ADDENDUM NUMBER 1

- 1.01 DATE: April 7, 2015
- 1.02 PROJECT: Interior Renovations to the Mimosa - G Residence
Ramapo College of New Jersey
- 1.03 SNS PROJECT NUMBER: 4698G

INTERIOR RENOVATIONS
AT THE
MIMOSA - G RESIDENCE

FIRST & SECOND FLOOR PLANS, DOOR SCHEDULE & DETAILS

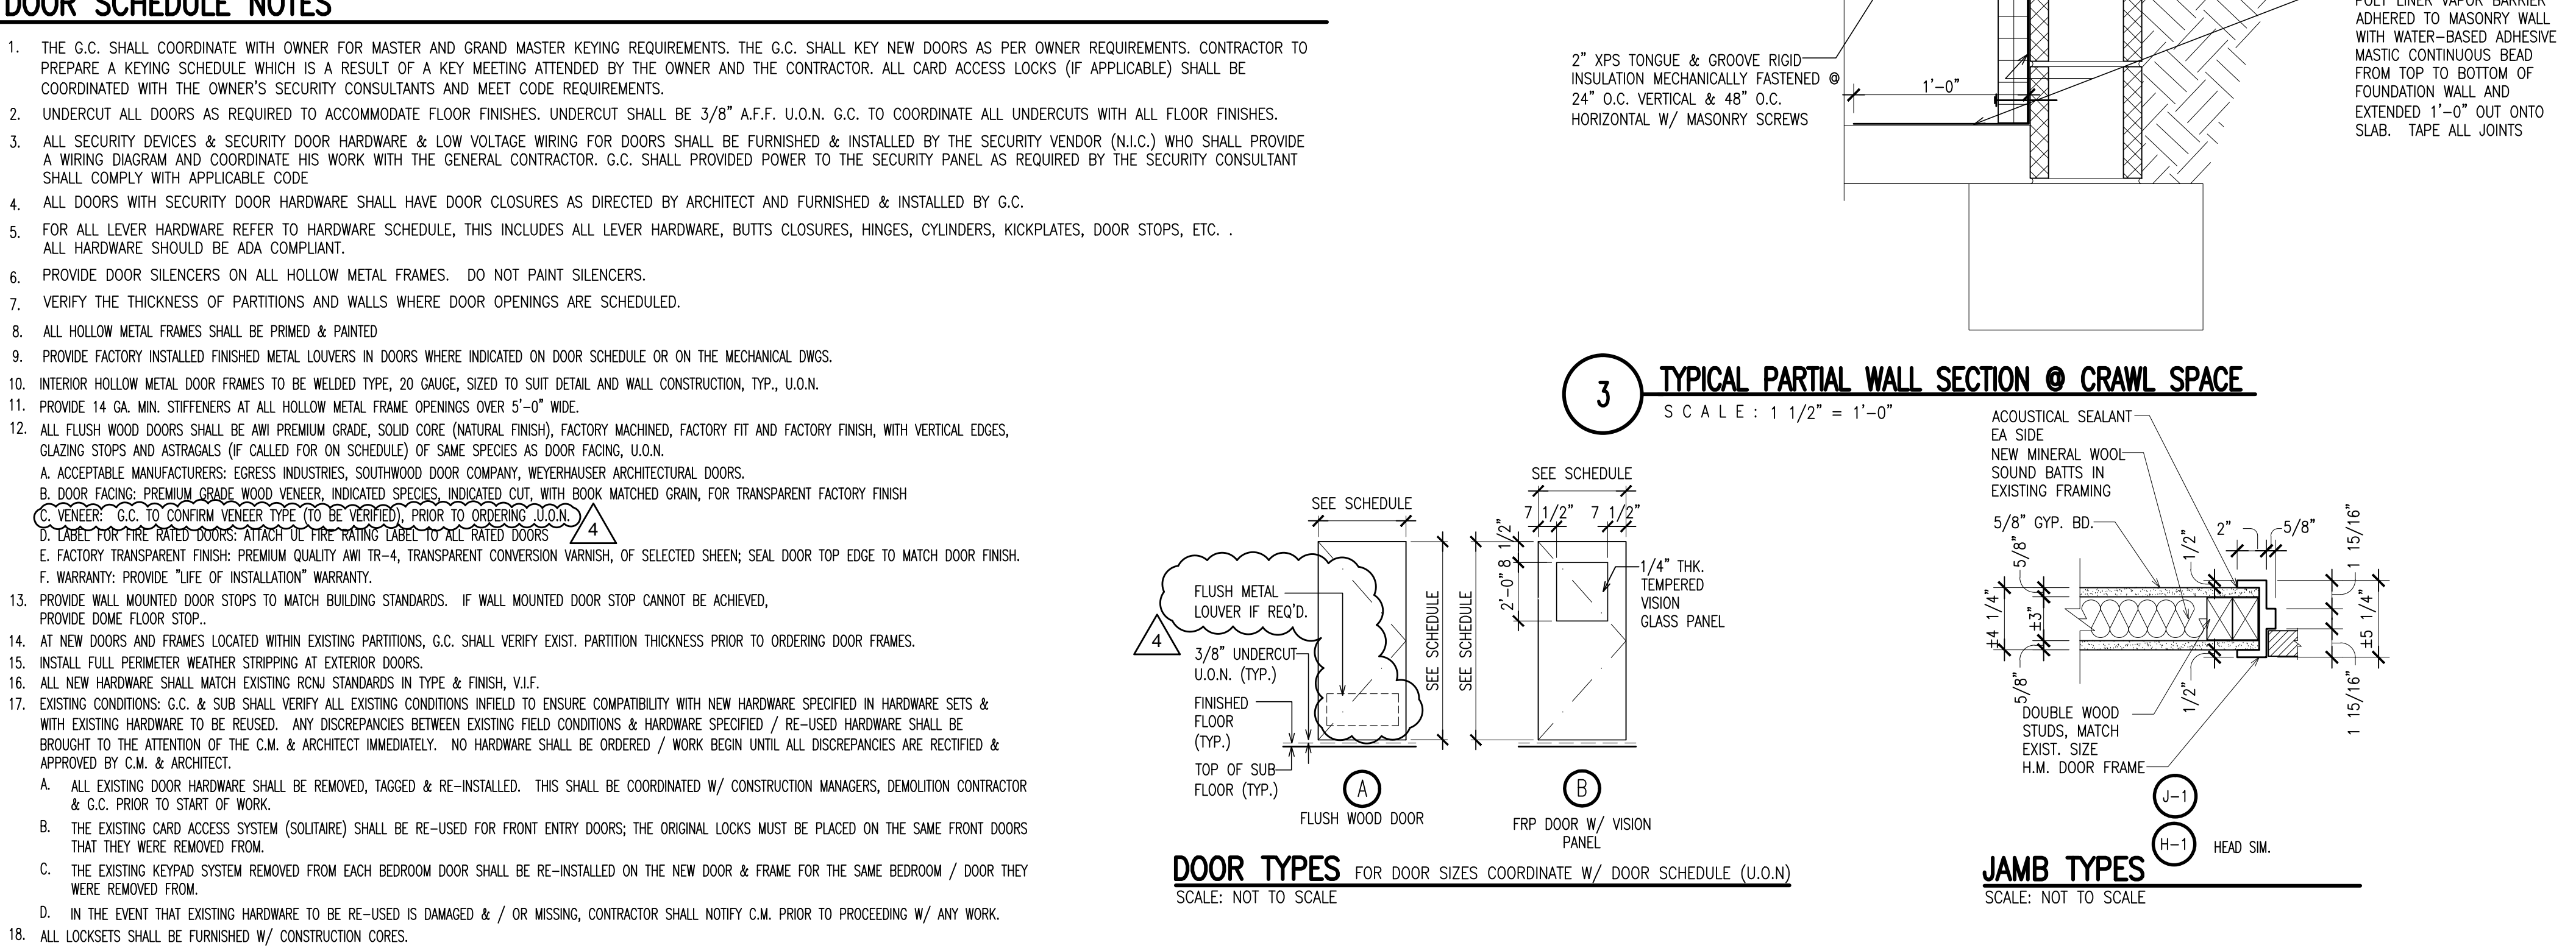
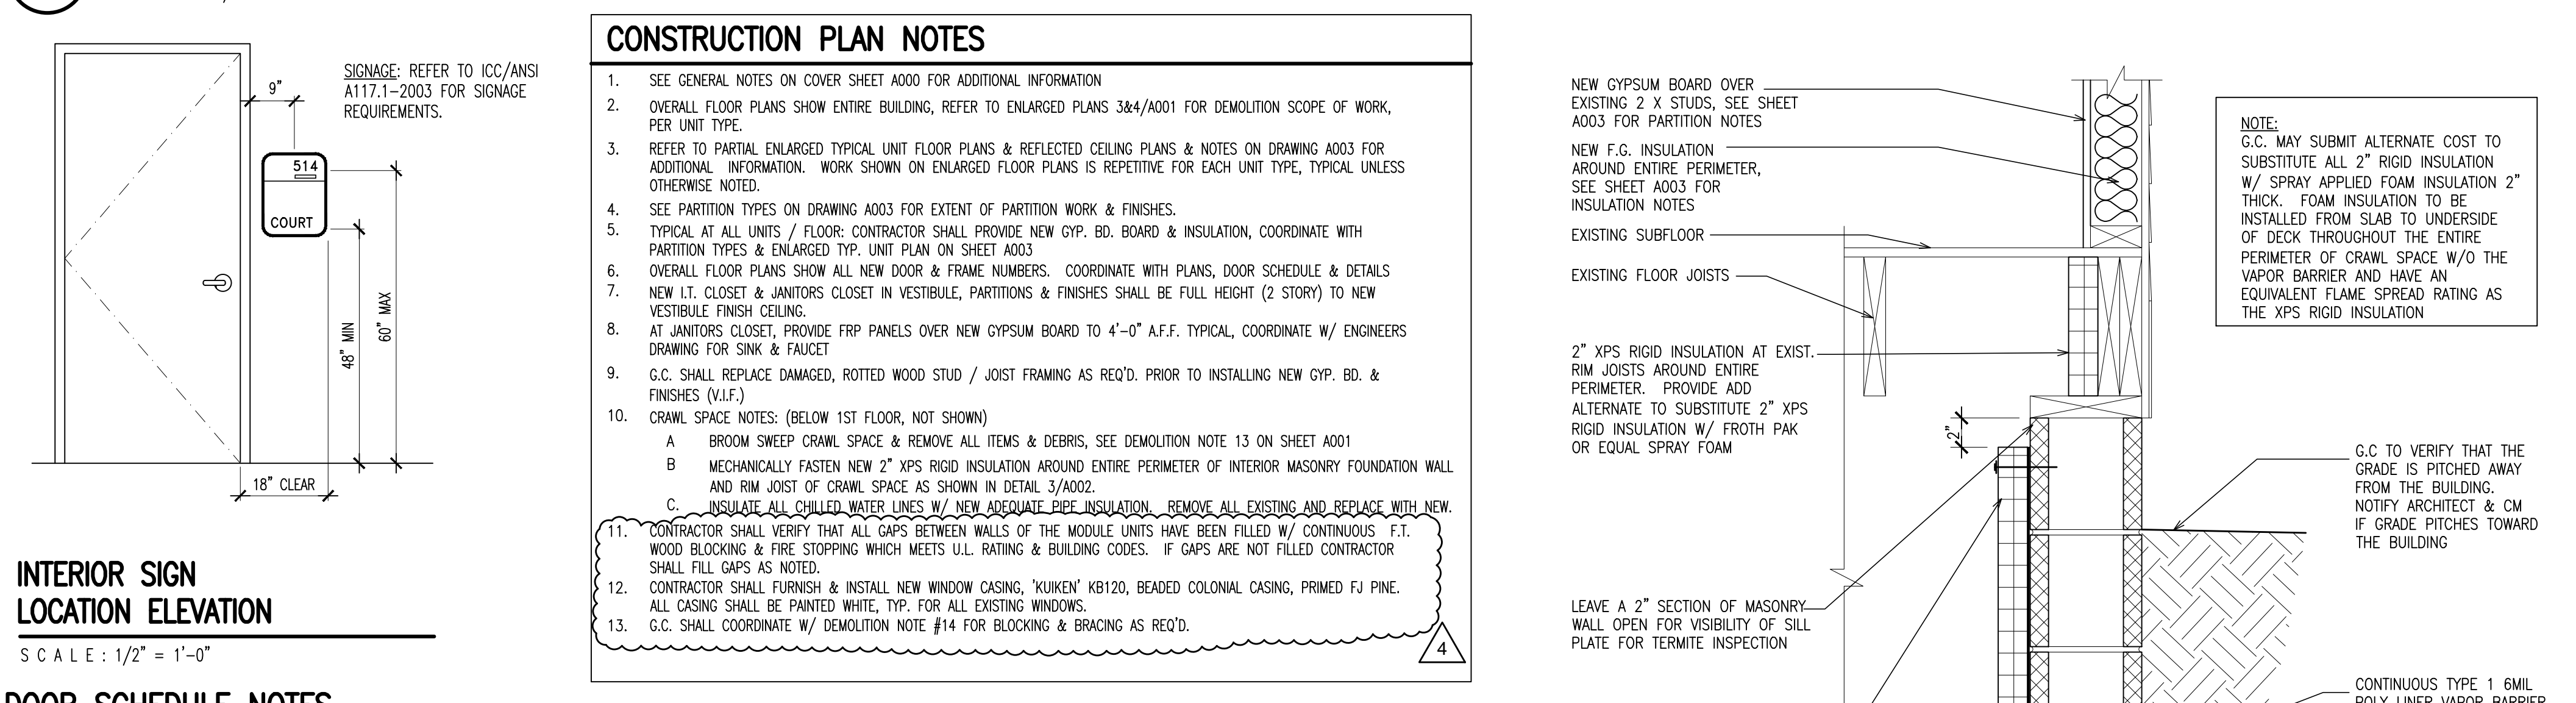
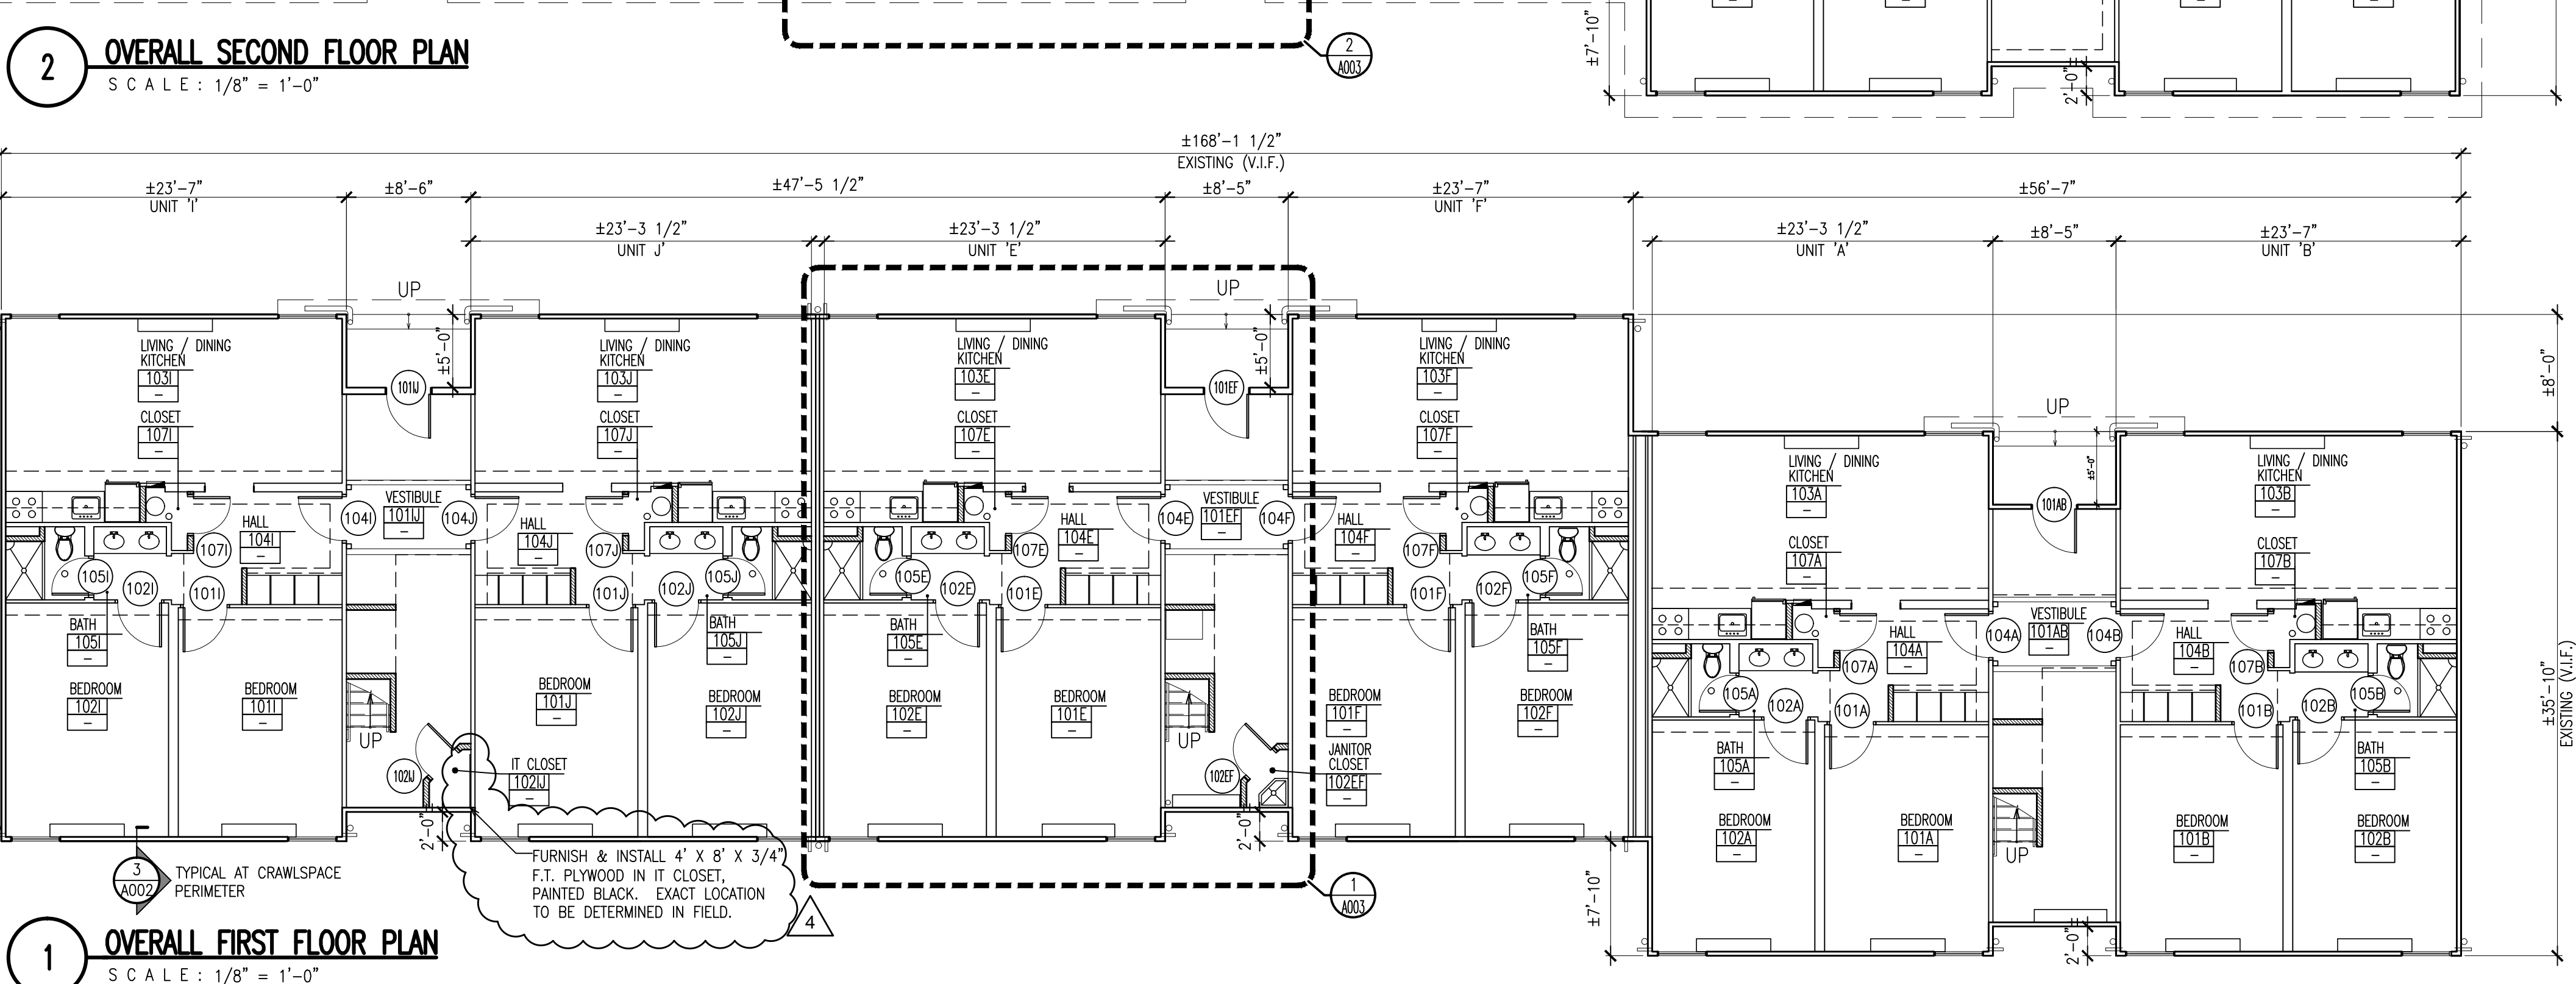
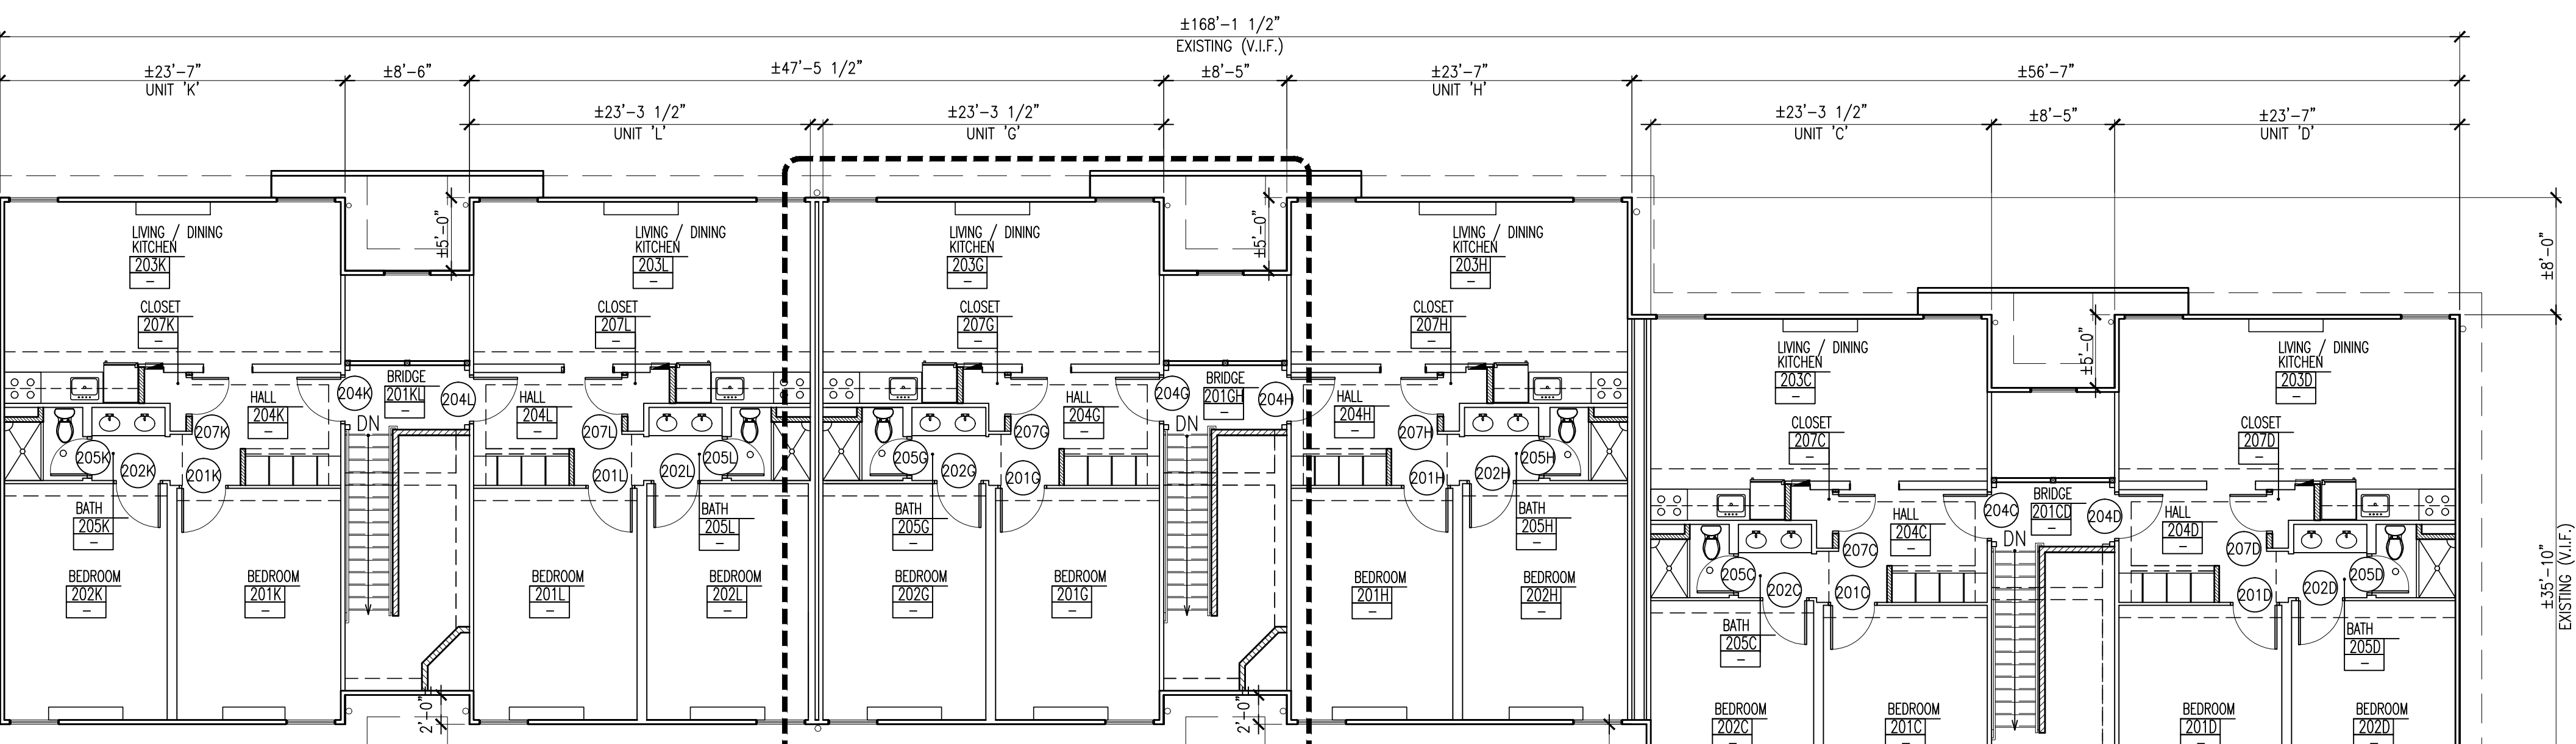
- 2.4. Room Sign & Signage Notes have been added to the drawings.
- 3. DRAWING A002, FIRST & SECOND FLOOR PLANS, DOOR SCHEDULE & DETAILS:
 - 3.1. Door Schedule: Door #102IJ, Remarks: “Provide Flush Metal Louver”.

- 3.2. Door Schedule Notes; Note #12-C has been revised.
 - 3.3. Door Type ‘A’, Flush metal louver has been added as to drawing.
 - 3.4. Construction Plan Notes:

- 3.4.1. Note #10-D has been removed.
 - 3.4.2. Note #11 has been revised.
 - 3.4.3. Note #12 has been revised.
 - 3.4.4. Note #13 has been added.
 - 3.5. Overall First Floor Plan 1/A002; I.T. Closet #102IJ: Note has been added”
Furnish and install 4’x8’x3/4” F.T. plywood in IT Closet, painted black, exact location to be determined in field”.
